Report Of The PCZBA Meeting - April 2, 2013

The Preserve's Subdivision - Double G's Restaurant Parking

STAFF REPORT

TO:	LONG GROVE PLAN COMMISSION
FROM:	JAMES M. HOGUE, VILLAGE PLANNER
DATE:	3/5/13
RE:	PCZBA REQUEST 02-13;

PROPOSED SITE PHOTOMETRIC PLAN

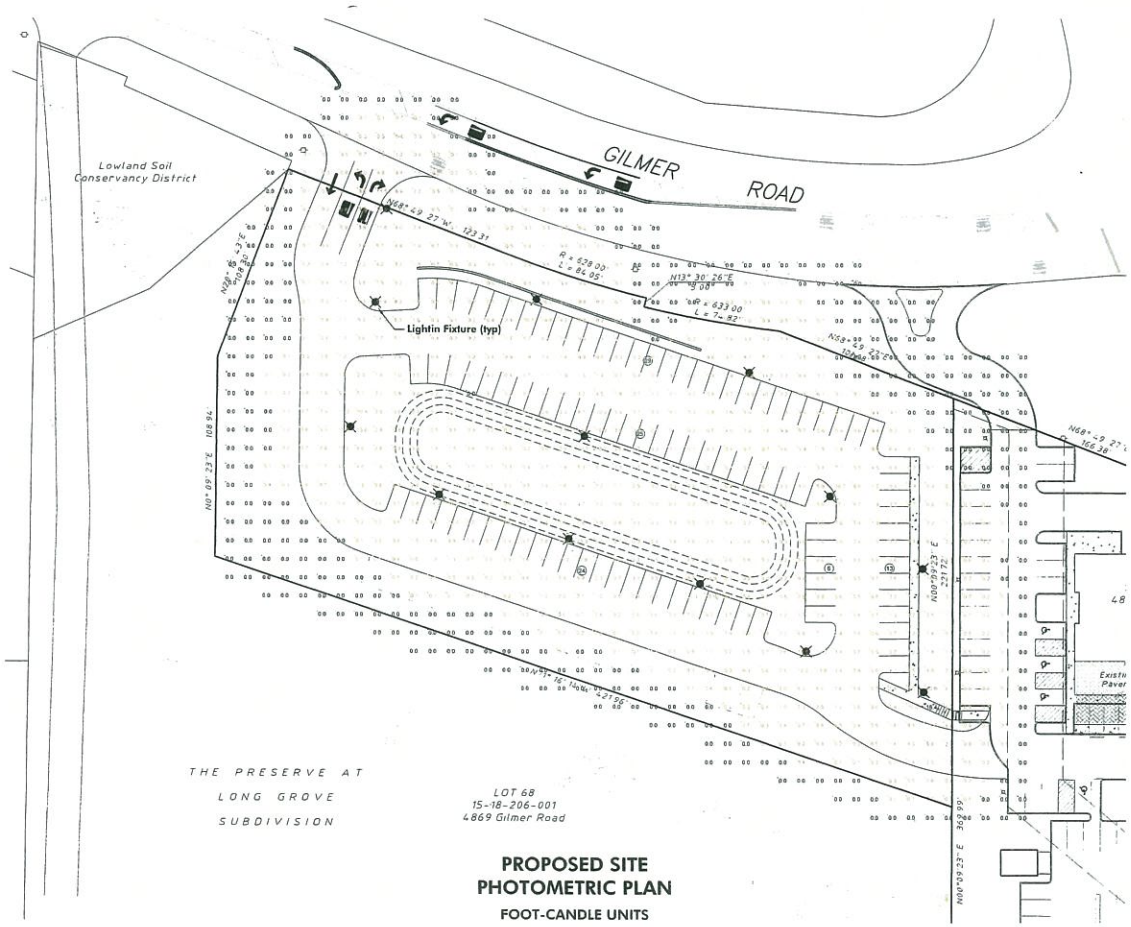
Twelve (12) 250 watt fixtures with a metal halide light source are proposed for parking lot lighting on Lot 68. Fixture have been located more or less toward the inside perimeter of the proposed parking area thereby minimizing the possibility of glare to adjacent residences particularly to the west of Lot 68. Metal halide light sources are permitted with AC approval; however, light sources over 200 watts are not permitted.

External lighting may not glare or "escape" into traffic or onto adjoining properties. This appears to have been met based upon the photometrics submitted. Variations to the exterior lighting requirements may be granted by the AC for "good cause".

SITE PLAN EXHIBIT

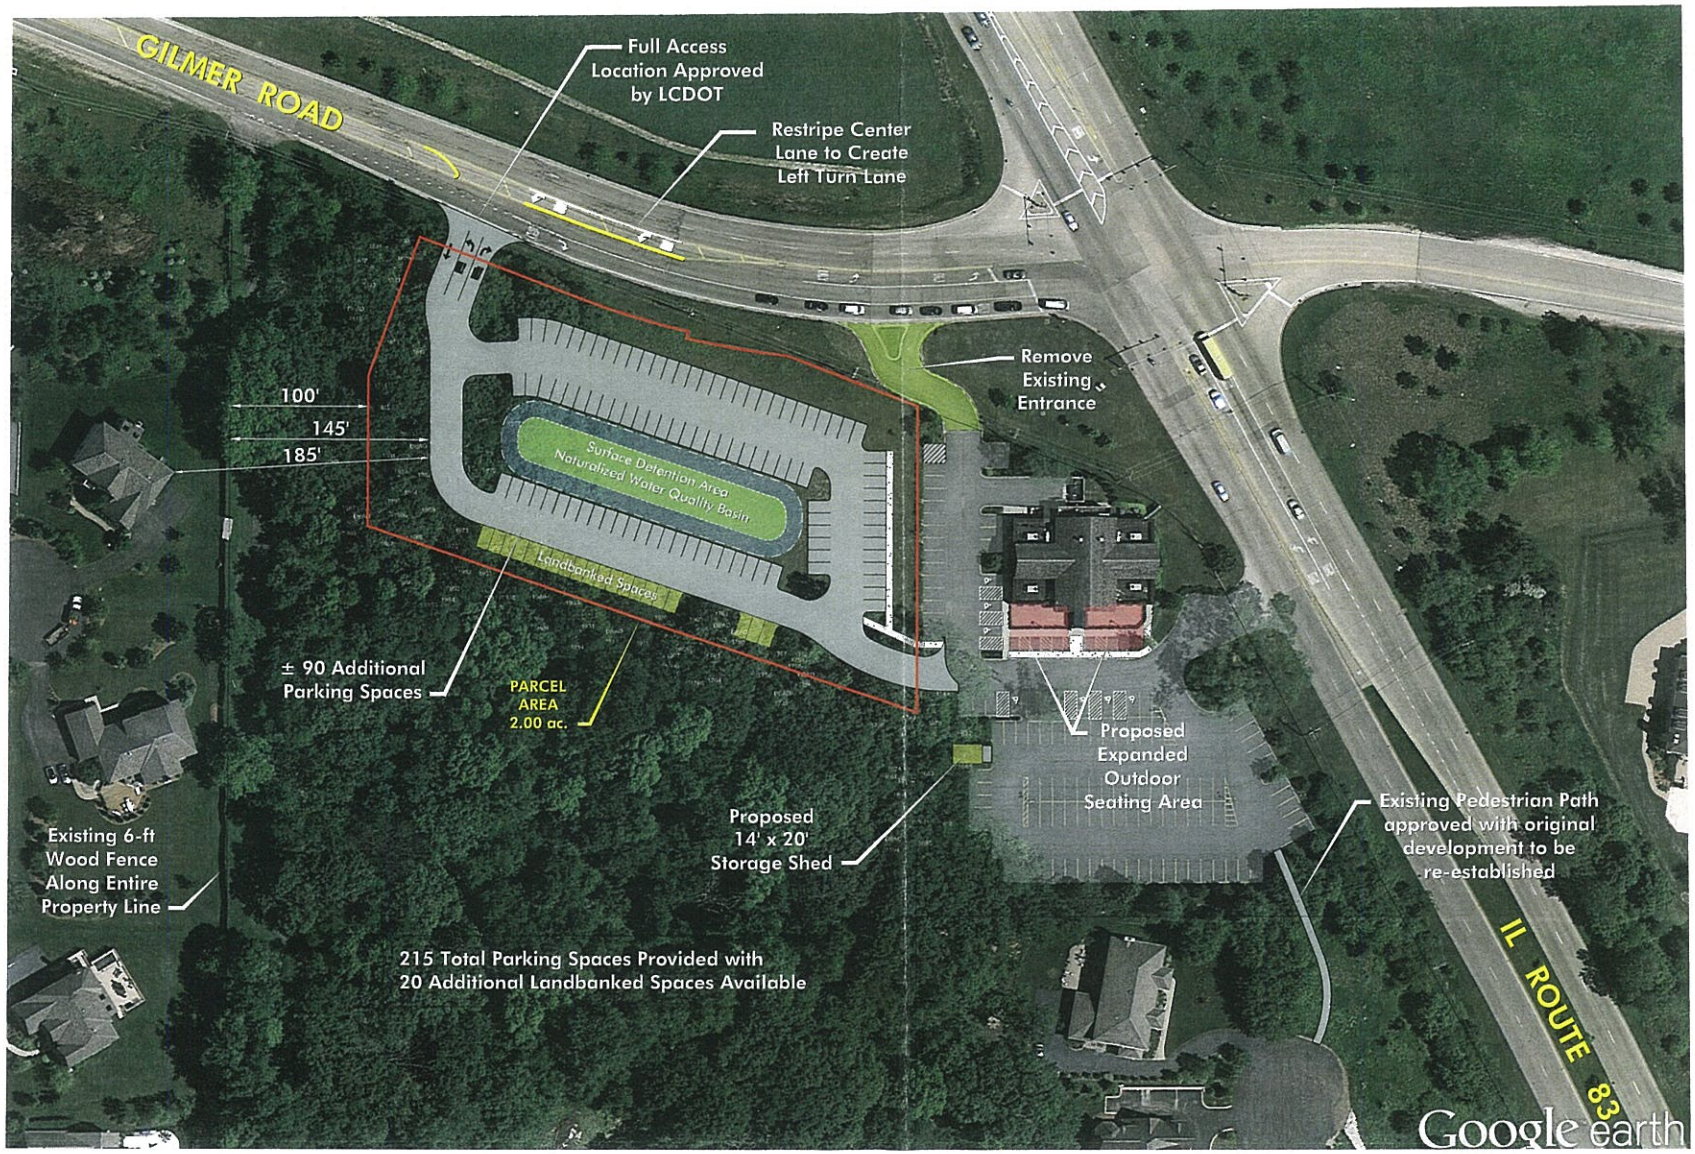
The site plan as proposed identifies most of the recommended improvements; it appears however a 25' turning radius is shown for inbound right turn movements as opposed to the 50' recommended radius.

SHEET NO.
L1

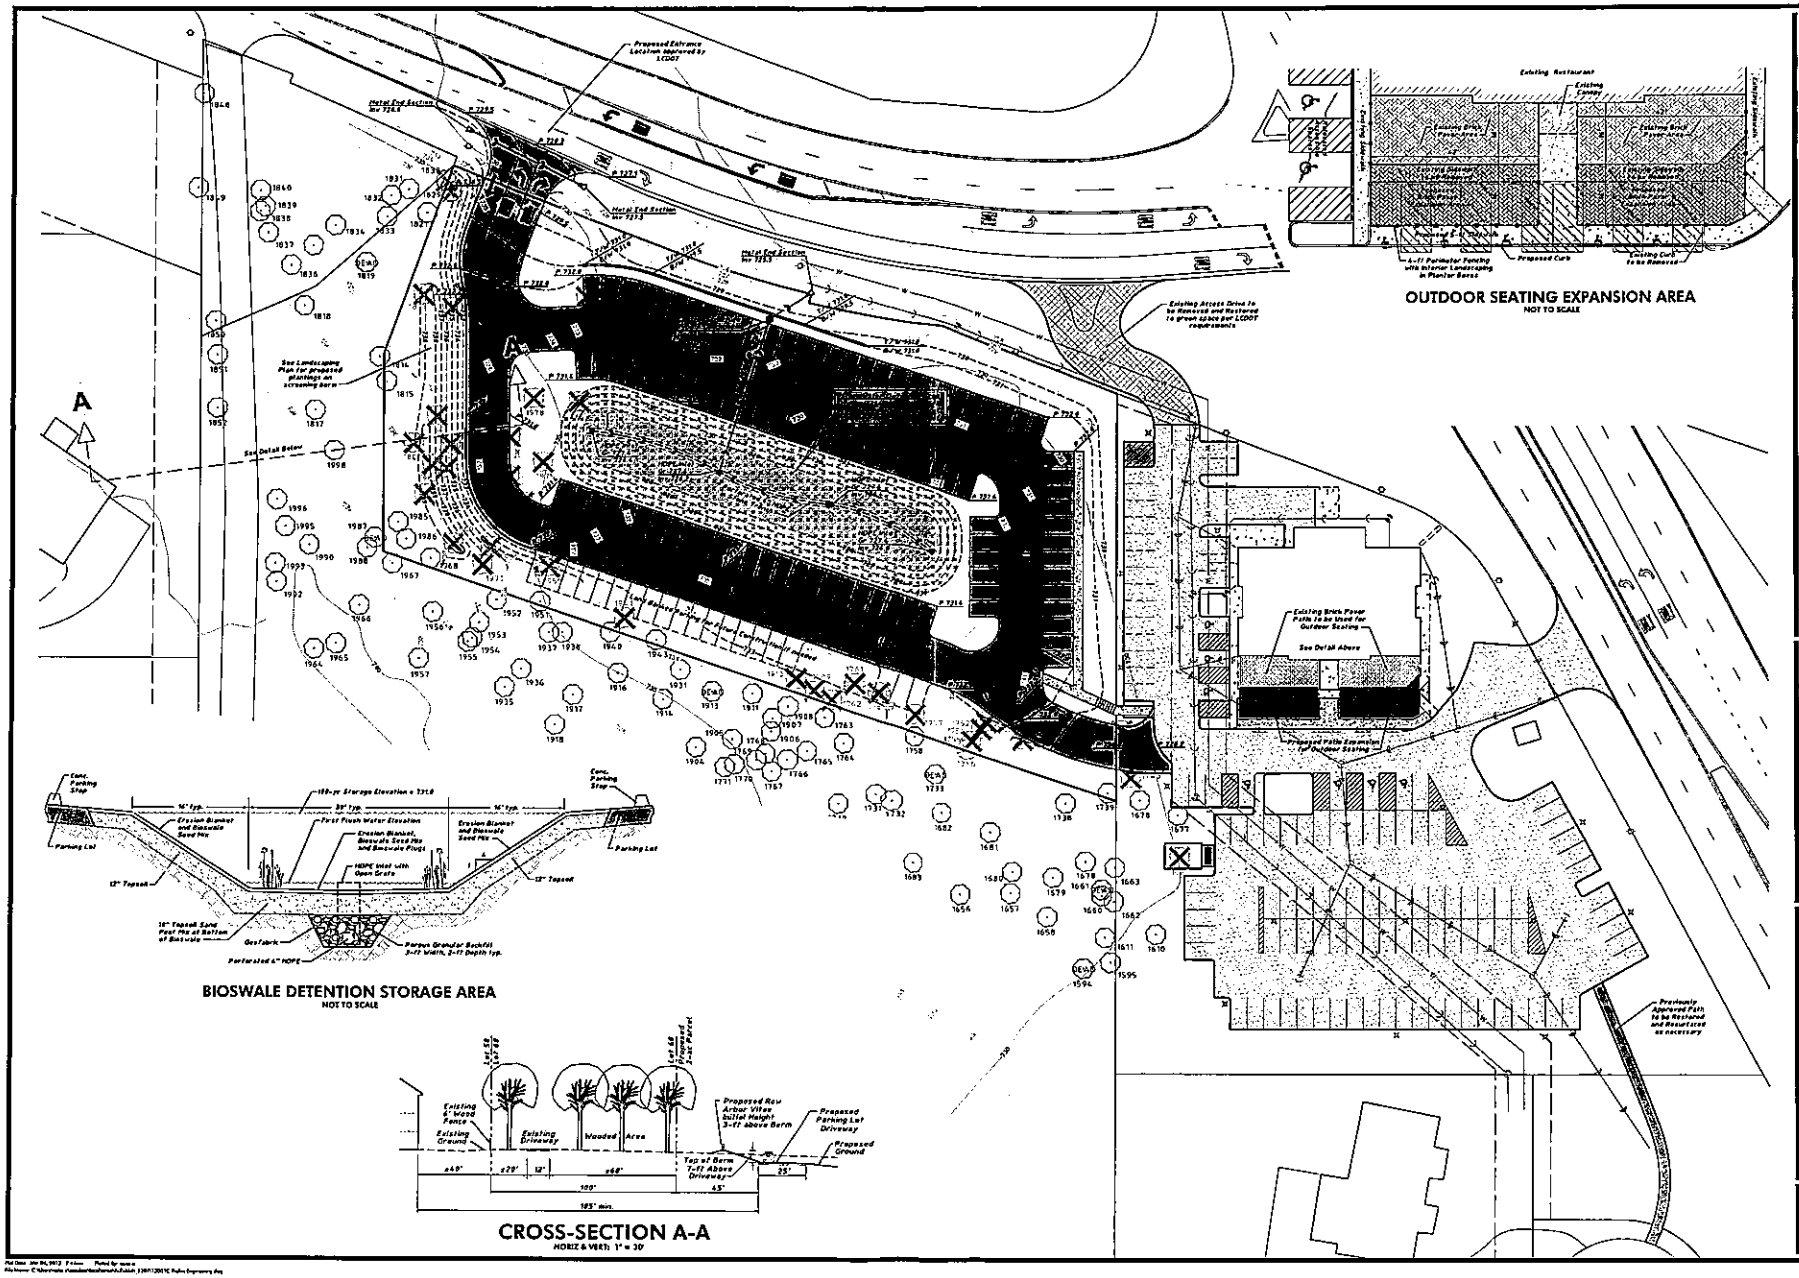
As proposed this standard appears to be exceeded. Additionally, a berm is contemplated along the west end of the property (nearest to the residences) of 7 feet in height as measured from the parking lot driveway. A fence, as well as landscaping on top of the berm is proposed to minimize any potential impact to the residential properties to the west (See cross-section A-A – attached). The detention/ bio-swale area in the center of the parking area is proposed to be planted with "bio-swale seed plugs" within the actual detention (wet) area and a prairie seed mix around the perimeter. The composition of the seed mixes have yet to be determined.
